Meeting: Traffic Management Meeting
Date: 25th April 2013
Subject: Hitchin Road and Clifton Road, Shefford - Consider Objections to Proposed Zebra Crossing and Waiting Restrictions
Report of: Jane Moakes, Assistant Director Community Safety and Public Protection
Summary: This report seeks the approval of the Executive Member for Sustainable Communities - Services for the installation of a zebra crossing and the introduction of waiting restrictions near the junction of Hitchin Road and Clifton Road, Shefford following the receipt of objections.

PROPOSED PEDESTRIAN CROSSING – HITCHIN ROAD, SHEFFORD

CENTRAL BEDFORDSHIRE COUNCIL PROPOSES TO INTRODUCE NO WAITING AT ANY TIME IN CLIFTON ROAD, SHEFFORD

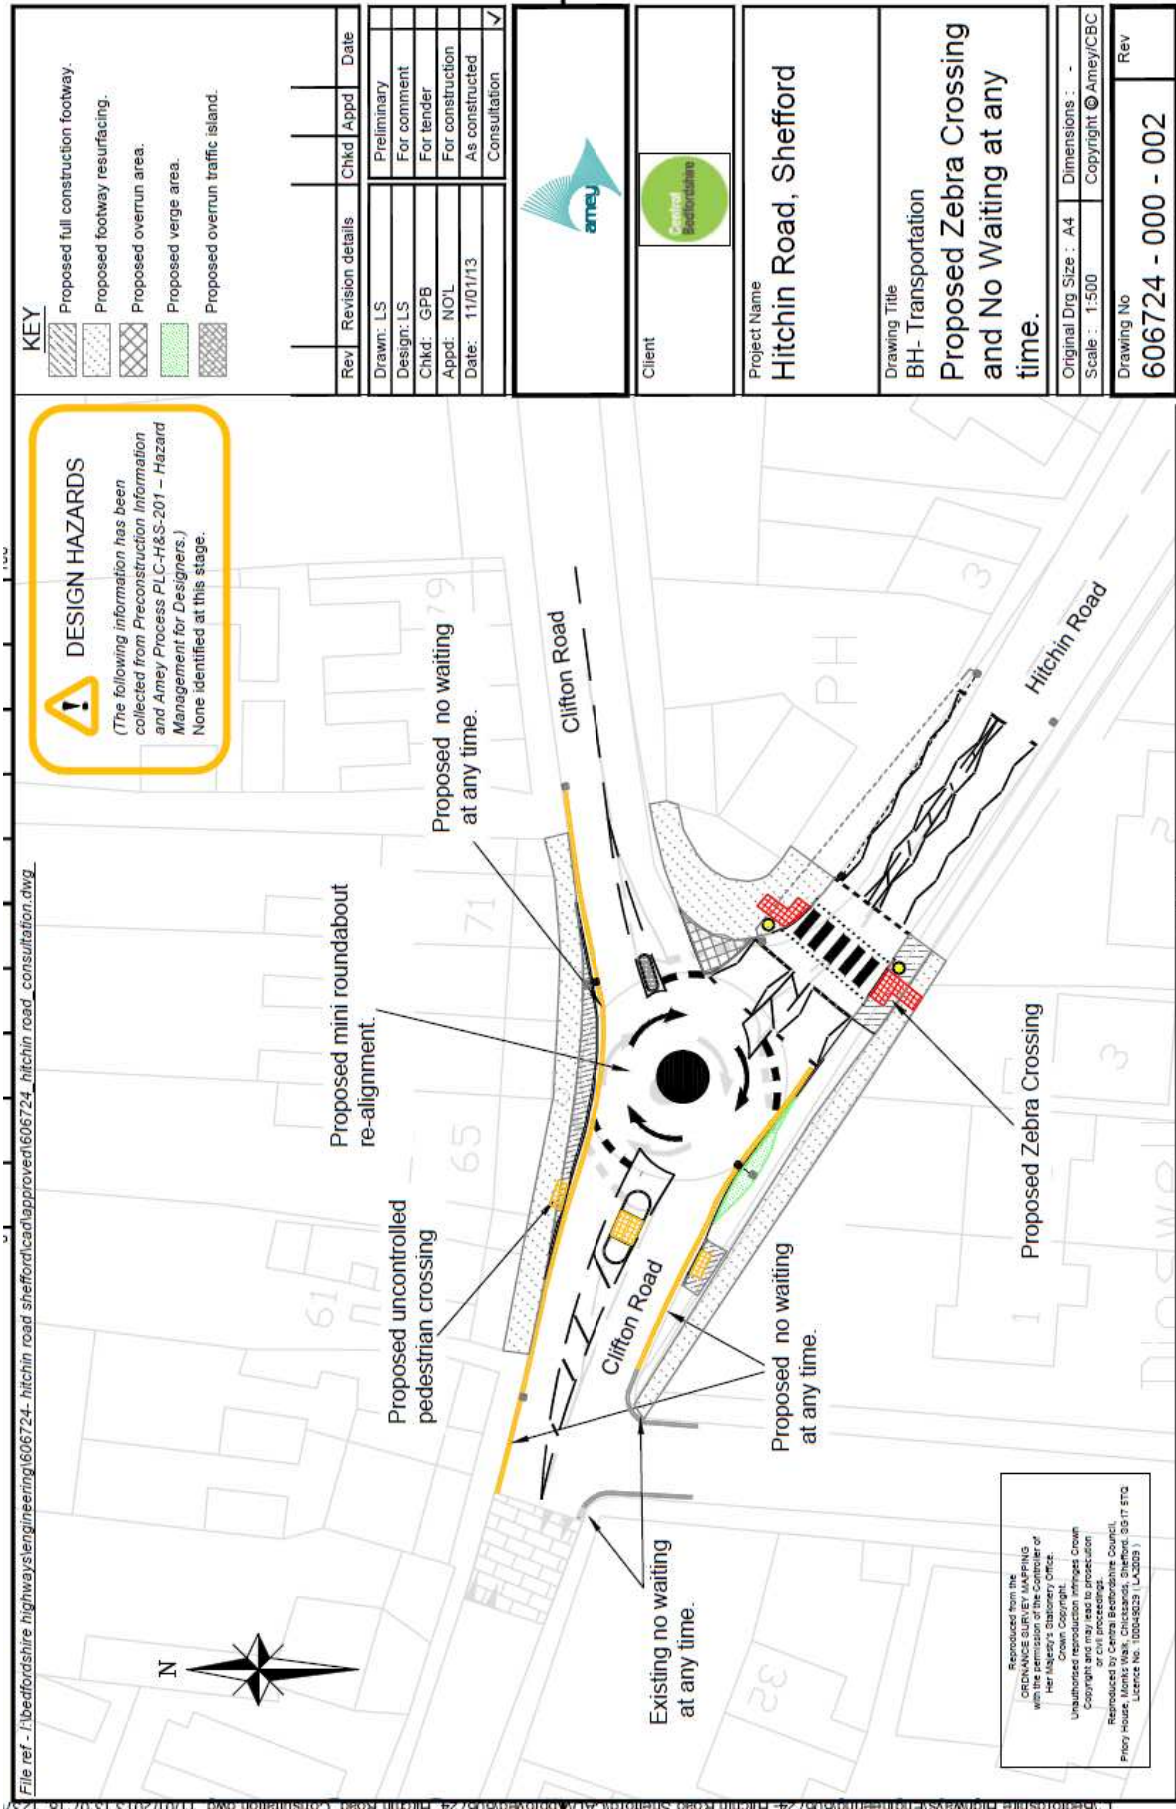
4. The main points raised by the objectors relate to the proposed waiting restrictions on Clifton Road and are as follows:-
 - a) The cottages on the north side of Clifton Road have no off-road parking and the uncontrolled crossing point and yellow lines would prohibit parking outside their homes.

- b) One of the objector's only means of access to his home is through a narrow walkway between adjacent properties. This has to be used for all items that he wishes to take into this home. The proposal would affect his life and make the property unsellable.

- c) Residents have restricted visibility when exiting their driveways and parked cars on the north side of Clifton Road mean that vehicles approaching from the west are more visible to residents leaving their driveways.

- d) The proposed restrictions will increase parking in Victoria Road where space is already limited.
5. The issues raised in the other representations are as follows:-

- a) Various issues relating to the design of the mini-roundabout, such as the removal of trees, manoeuvring space for larger vehicles, will not reduce speeds or improve safety.

- b) Parking restrictions should also be considered on the south side of Clifton Road.
 - c) The location of the zebra crossing in relation to the mini-roundabout.
6. Bedfordshire Police has no objection to any of the proposals.

7. Bedfordshire Highways' response to the specific points listed in 4. above are as follows:-
- a) It is accepted that there are properties on this length of Clifton Road that have no off-road parking. However, it is not ideal for parked cars to be positioned on the immediate approach to a mini-roundabout. In addition, as part of the re-design of the mini-roundabout, the footway on the north side of Clifton Road is being widened, so there is less road width at that point to accommodate on-street parking. There are concerns that the parked cars encourage passing traffic to move towards the centre of the road and consequently take a straight line through the junction, particularly when heading towards Hitchin Road.

- b) Residents would still be able to stop on the proposed yellow lines to load/unload and to pick up/set down passengers. There is un-restricted parking within a short walking distance in Clifton Road and Victoria Road.

- c) This point is acknowledged, but the footway widening on the north side of Clifton Road provides some entry deflection, which will alter the position of vehicles entering the roundabout and reduce their speed. This should go some way to addressing residents' concerns.

- d) If the parking restrictions are implemented, Victoria Road is very likely to be an attractive alternative for residents unable to park outside their own home. Victoria Road does have some properties that have no off-road parking, although there is a reasonable amount of kerbside parking space available and very few parking controls.

8. Bedfordshire Highways' response to the specific points listed in 5. above are as follows:-
- a) The proposed re-alignment of the mini roundabout is designed to increase vehicle entry deflection, which should help to reduce approach speeds. All approaches were modified to improve visibility, especially on the westbound carriageway of Clifton Road heading towards the town centre.
Auto track software has been used to predict vehicle paths and this has been incorporated into the detailed design. Traffic information and accident data were checked and considered in the design. The scheme will include the removal of vegetation (subject to ecological survey) to avoid the belisha beacons being obscured.
As a further safety improvement, it is intended to publish a proposal to extend the existing 20mph zone in the town centre eastwards to cover the Clifton Road/Hitchin Road junction. This should further reduce traffic speeds at this location. The required notices should be published in the coming weeks.

- b) More extensive parking restrictions could be considered for that part of Clifton Road west of the Hitchin Road mini-roundabout, but this would further reduce the amount of on-road parking available for those who need it. Given that Clifton Road is relatively straight at this location, extensive yellow lines are likely to increase vehicle speeds, which is not desirable. It is seen as peripheral to the crossing scheme and, if justified, would need to be considered as a separate exercise.
- c) The zebra crossing was designed to be sited as close as possible to the desirable pedestrian crossing line and complies with all relevant design guidance. If the crossing was located further away, such that pedestrians had to deviate from their walking route, then it is likely that they would simply not use it.
